Office Action Summary

10/582,032

JOHANSSON ET AL.

ATTACHMENT

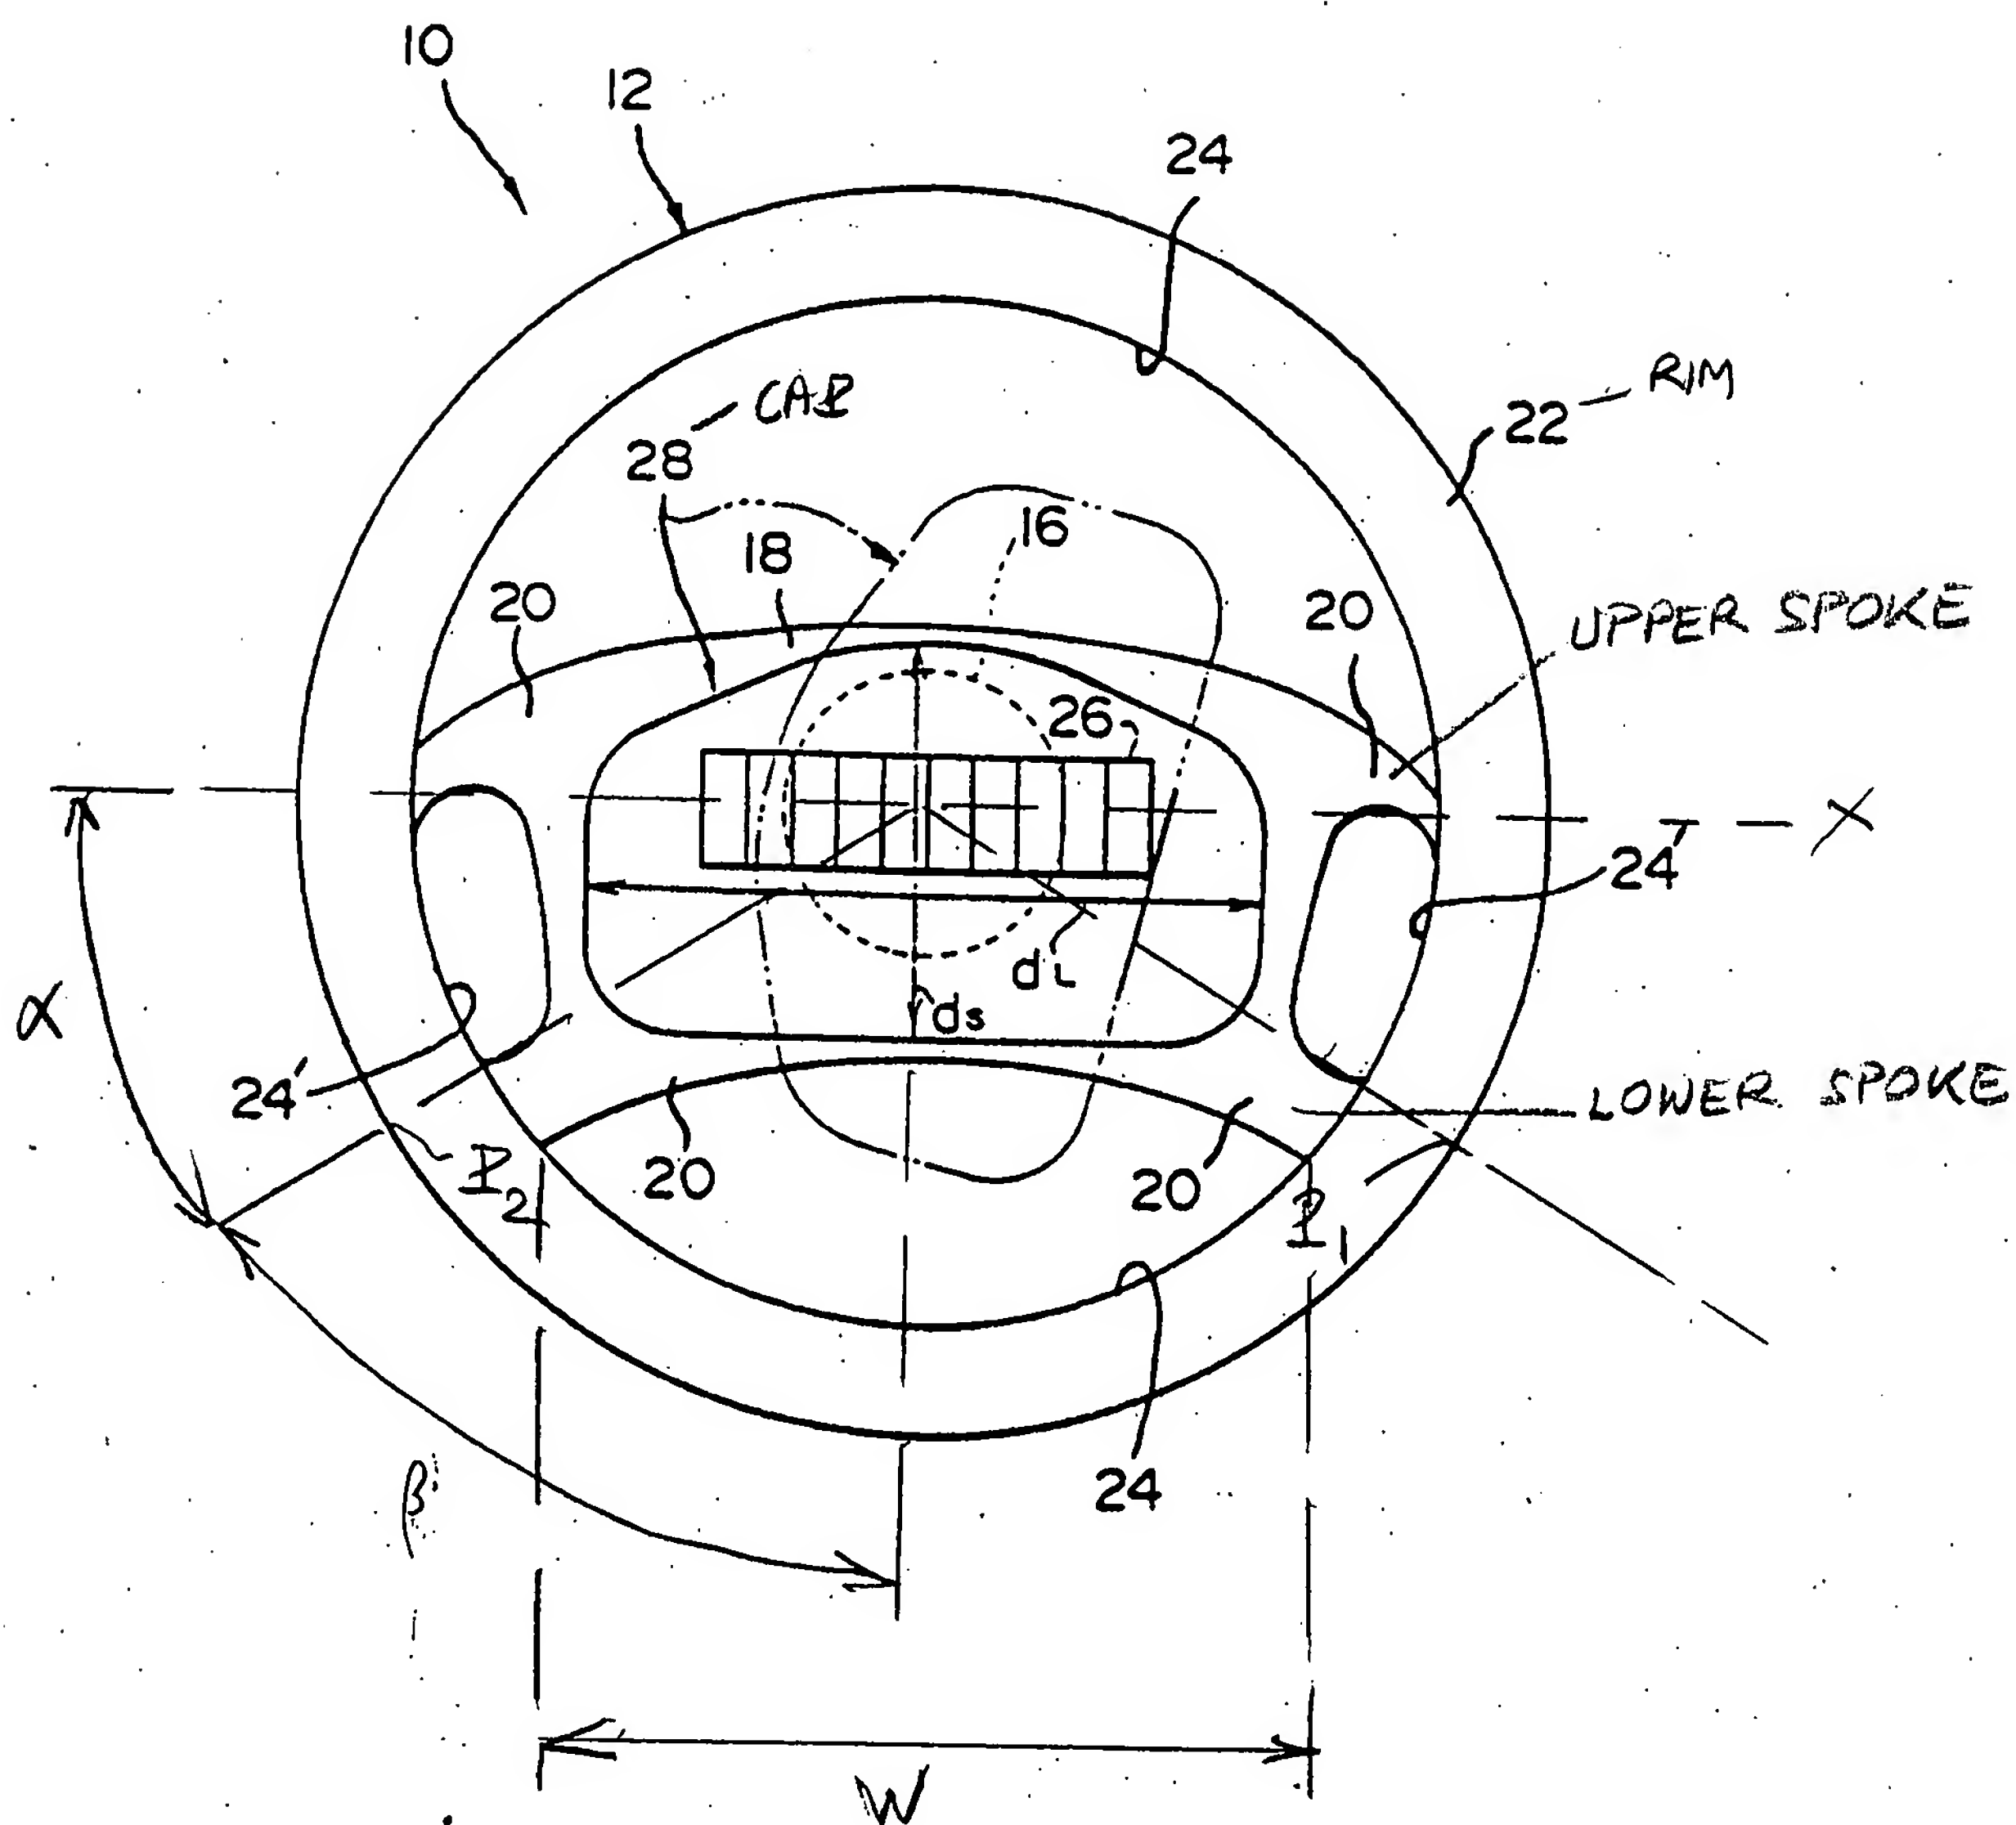
two lower spokes 20 also extending between the signal cap 28 and the rim 22, the lower spokes 20 having an upper edge (see Attachment hereinafter "Att.");

the two lower spokes 20 are shaped and positioned to be graspable by a normal man's hand, the lower spokes 20 extend from positions around the rim 22 so that points (P_1 and P_2 in Att.) that are in line with the upper edge of the respective lower spokes 20 on the outer surface of the rim 22 are located between 30° and 60° (see angle α in Att.) below the horizontal symmetry axis on either side of the vertical symmetry axis Y of the steering wheel 10, and the upper edge of the lower spokes 20 is in line with the respective points (P_1 and P_2 in Att.) and forms an angle (β in Att.) of between 62° and 82° with the vertical symmetry axis Y of the steering wheel 10, and a multifunctional switch module 26 including control buttons operable for remote actuation of vehicle functions, the module 26 is located between the two lower spokes 20 on the signal cap 28, whereby the driver can operate the module 26 while grasping the lower spokes 20. Ibid. col. 4, line 57+.

Regarding Claim 2, the two points (P_1 and P_2 in Att.) are situated about 30° below the horizontal symmetry axis X (FIG. 5) on either side of the vertical symmetry axis Y of the steering wheel 10. To change the instant angle to 40° would have been a matter of choice in design since the claimed structures and the function they perform are the same as the prior art. *In re Chu*, 66 F.3d 292, 36 USPQ2d 1089 (Fed. Cir. 1995) citing *In re Gal*, 980 F.2d 717, 719, 25 USPQ2d 1076, 1078 (Fed. Cir. 1992). See also legal precedent regarding changes in size/proportion in MPEP 2144.04.

Regarding Claims 3 and 4, the angle (β in Att.) from the vertical symmetry axis Y of the steering wheel 10 to the respective points (P_1 and P_2 in Att) are about 60° . To change this angle to between 67° and 77° or 72° would have been a matter of choice in design since the claimed structures and the function they perform are the same as the prior art. *In re Chu*, *Ex parte Smith*, and MPEP 2144.04, *supra*.

Regarding Claims 6 and 7, a width (W in Att.) of the graspable part of the upper edge of the lower spokes 20 is measured at a certain mm. To change this width to between 65 mm and 105 mm or about 85 mm would have been a matter of choice in design since the claimed structures and the function they perform are the same as the prior art. *In re Chu, Ex parte Smith*, and MPEP 2144.04, *supra*.
